**TOWN OF NEWBURGH
PLANNING BOARD
REVIEW COMMENTS**

PROJECT: DICHIARO SUBDIVISION
PROJECT NO.: 14-20
PROJECT LOCATION: SECTION 3, BLOCK 1, LOT 35.22
PROJECT REPRESENTATIVE: MERCURIO-NORTON-TAROLLI-MARSHALL
REVIEW DATE: 3 NOVEMBER 2014
MEETING DATE: 6 NOVEMBER 2014

Re: Job No. 3720
Lands of Marguerite DiChiaro
Tax Map Parcel: 3-1-35.22
Town of Newburgh, Forest Road
3-Lot Residential Subdivision
Newburgh Project No. 2014-20

Survey Map, Subdivision, & Site Plan for Lands of Marguerite DiChiaro

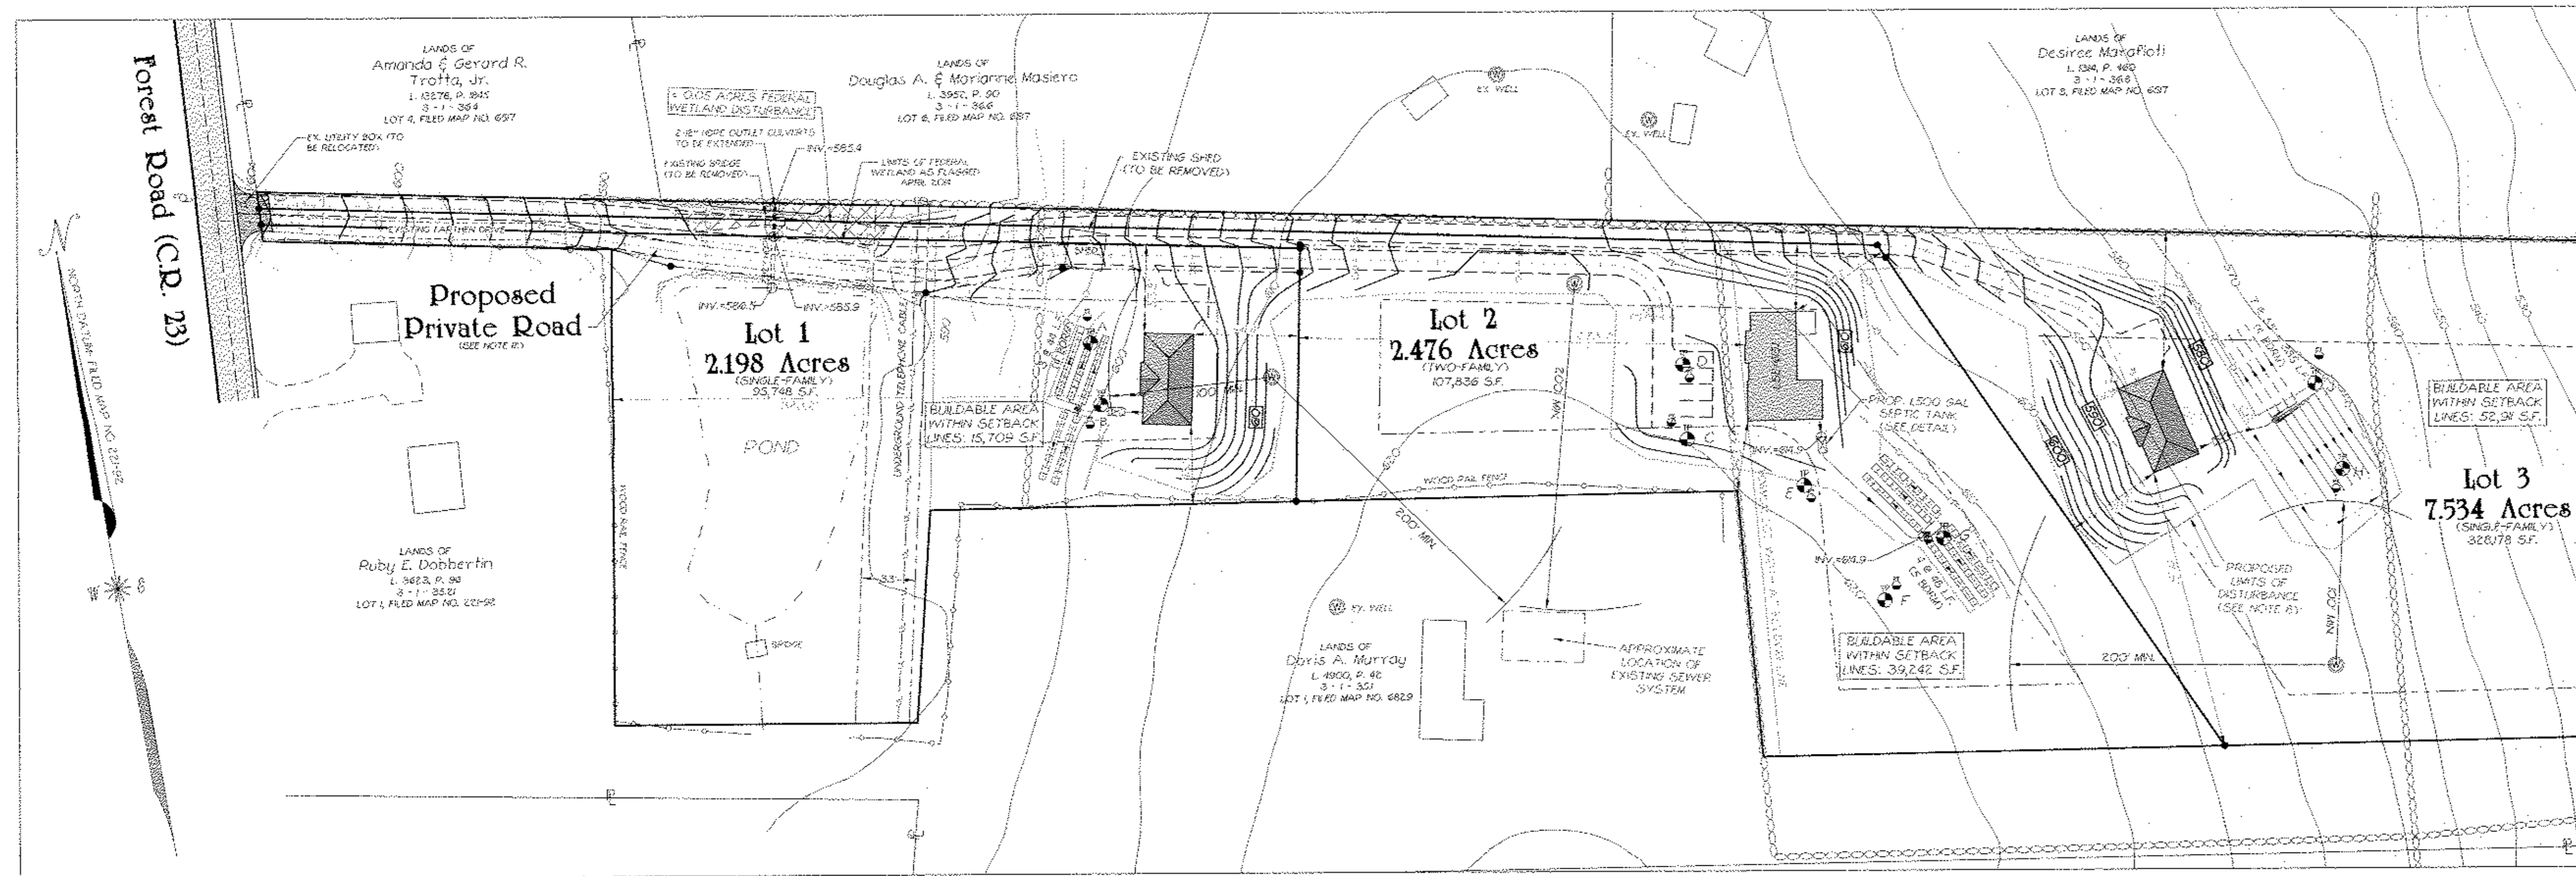
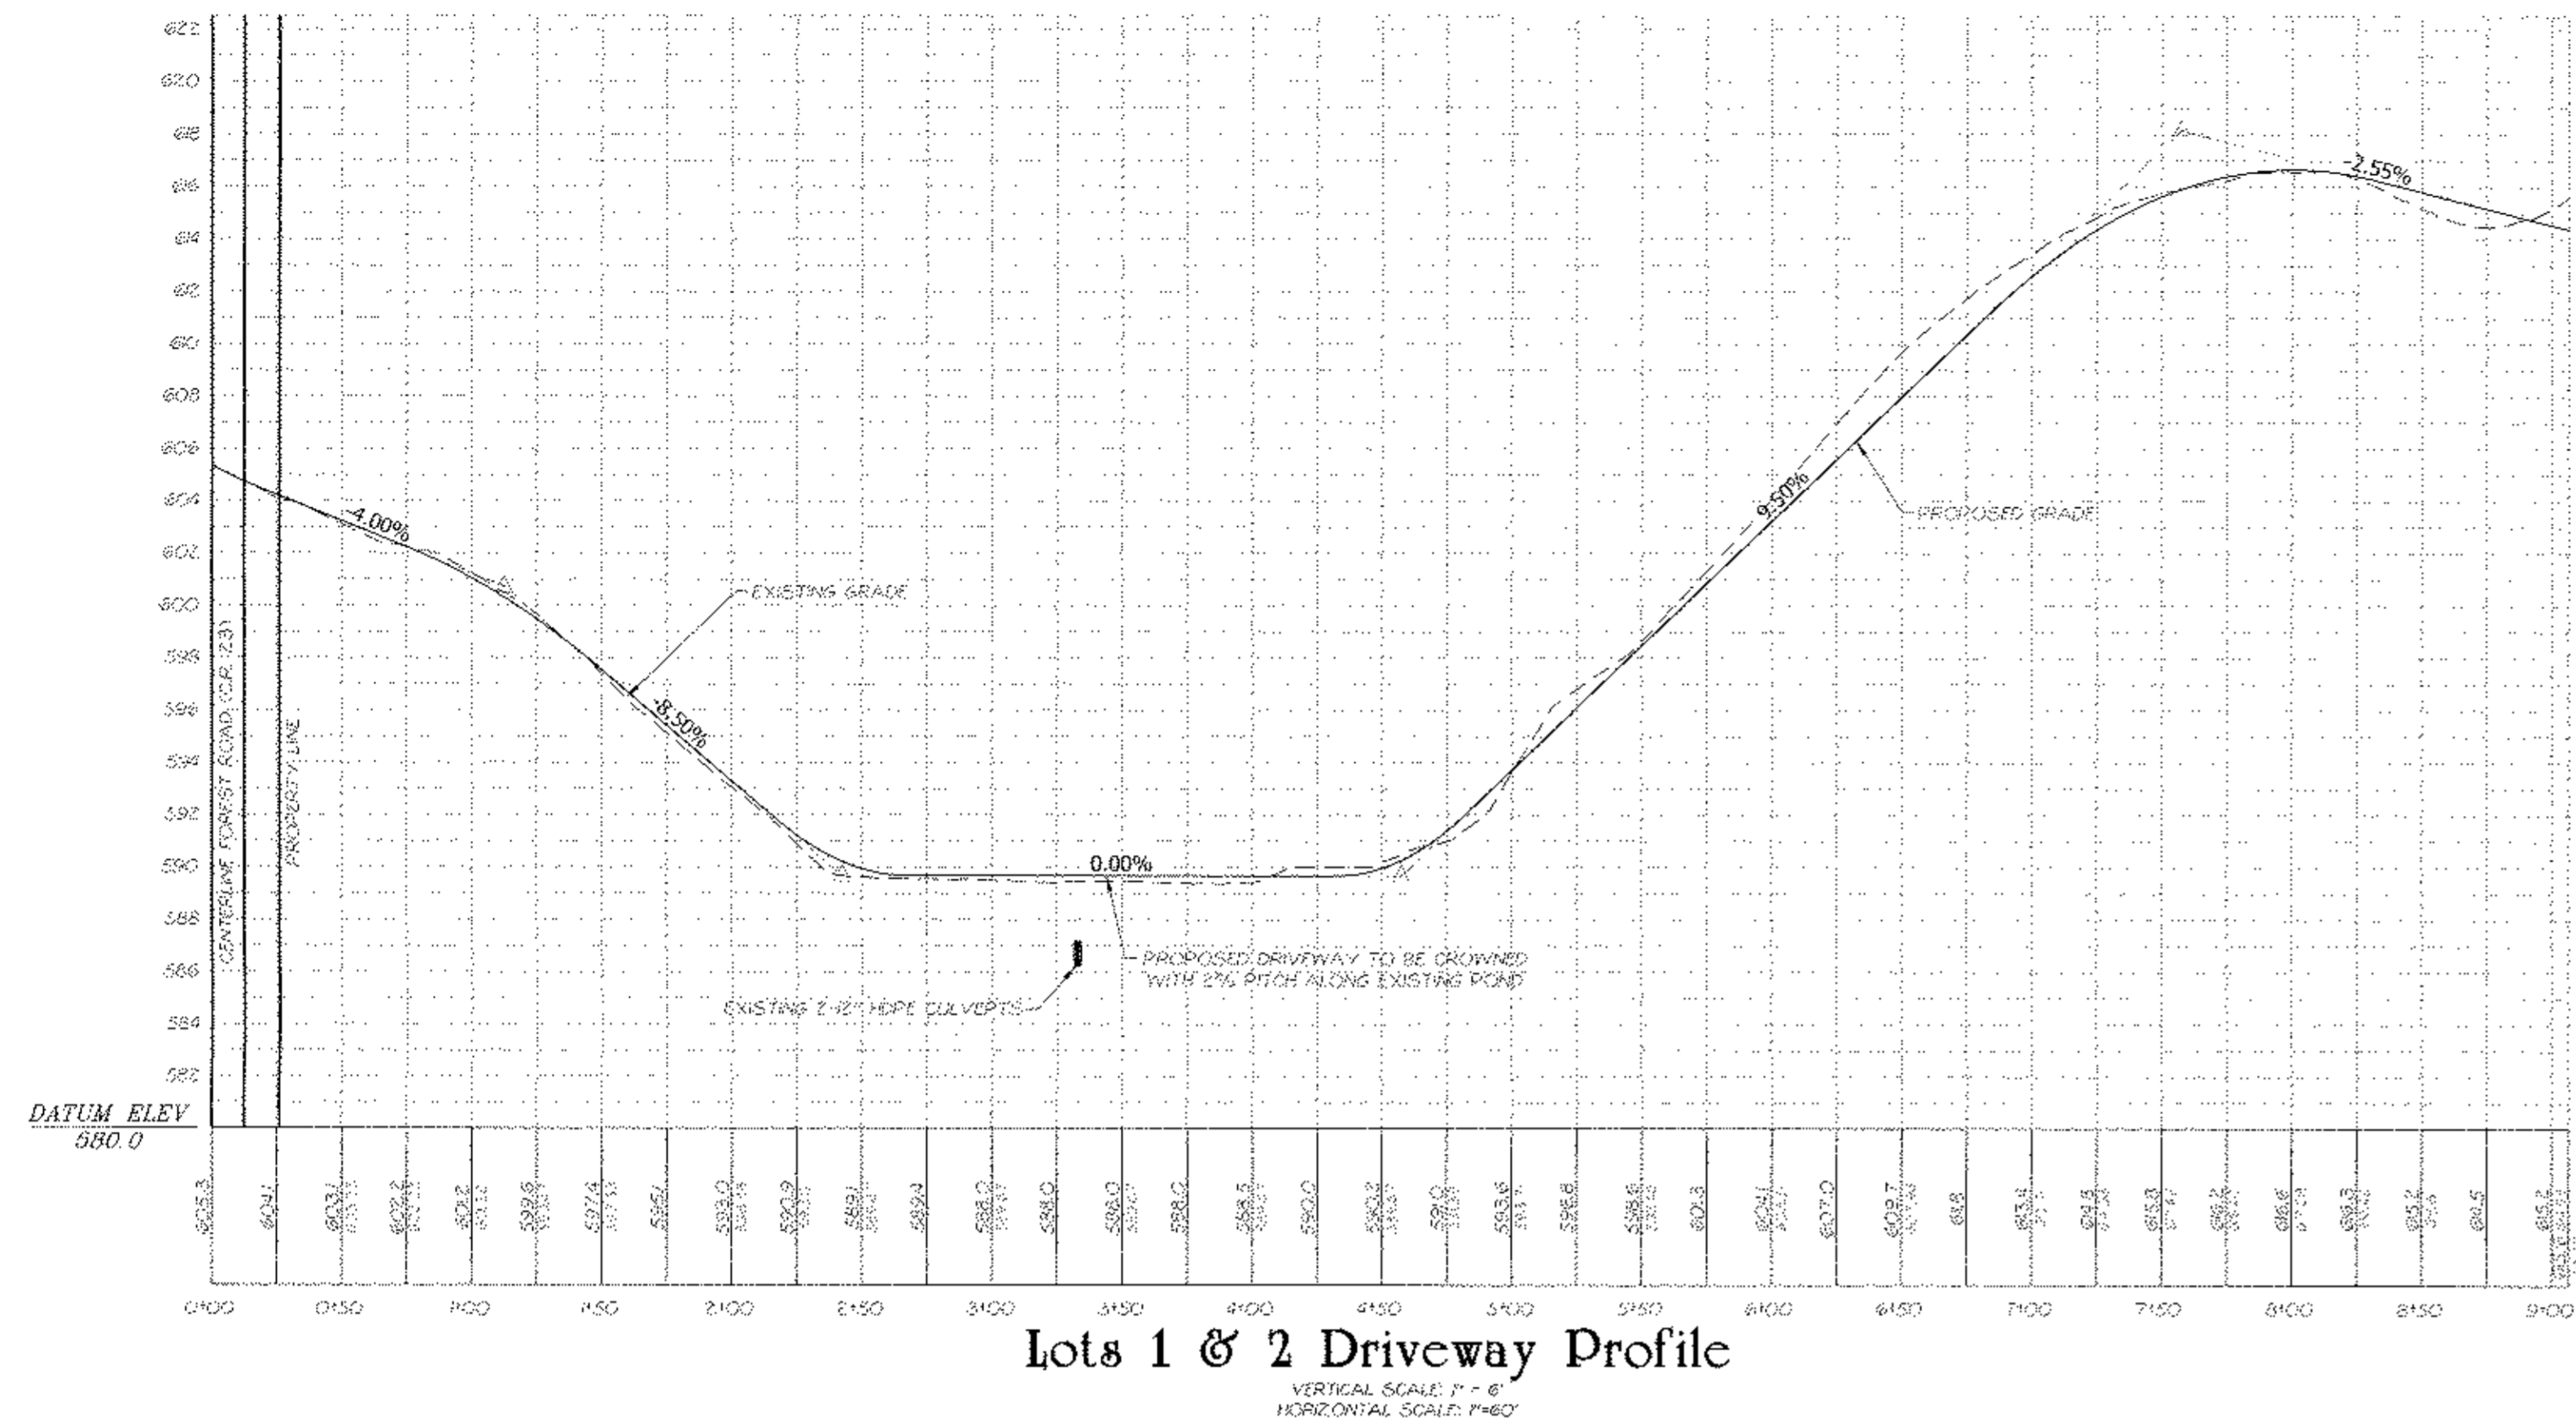
1. Comments from Orange County Department of Public Works should be received as to driveway access. A permit from the Public Works is required.
2. Plans have been revised pursuant to our 16 September 2014 comments.
3. Orange County Planning submission was made on 9 October 2014. Timeframe for County review will not have expired as of the date of this meeting, unless comments have been received.
4. Road name is required. Submission of a road name to the Town Board for approval should be a condition of approval.
5. Planning Board should perform architectural review of the proposed duplex for Lot 2.

7. An NOI has been prepared for the project. An MS4 Acceptance Form will be required prior to submitting to NYSDEC for permit coverage.
8. Note 10 on sheet 1 has been added stating the proposed two-family dwelling on Lot 2 shall be staked out by a N.Y.S. Licensed Land Surveyor prior to construction.
9. The proposed 1,500 gallon septic tank on Lot 2 has been labeled on sheet 1.
10. The proposed type of system for Lot 3 has been revised in the Sewage Disposal System Requirements Table on sheet 3.
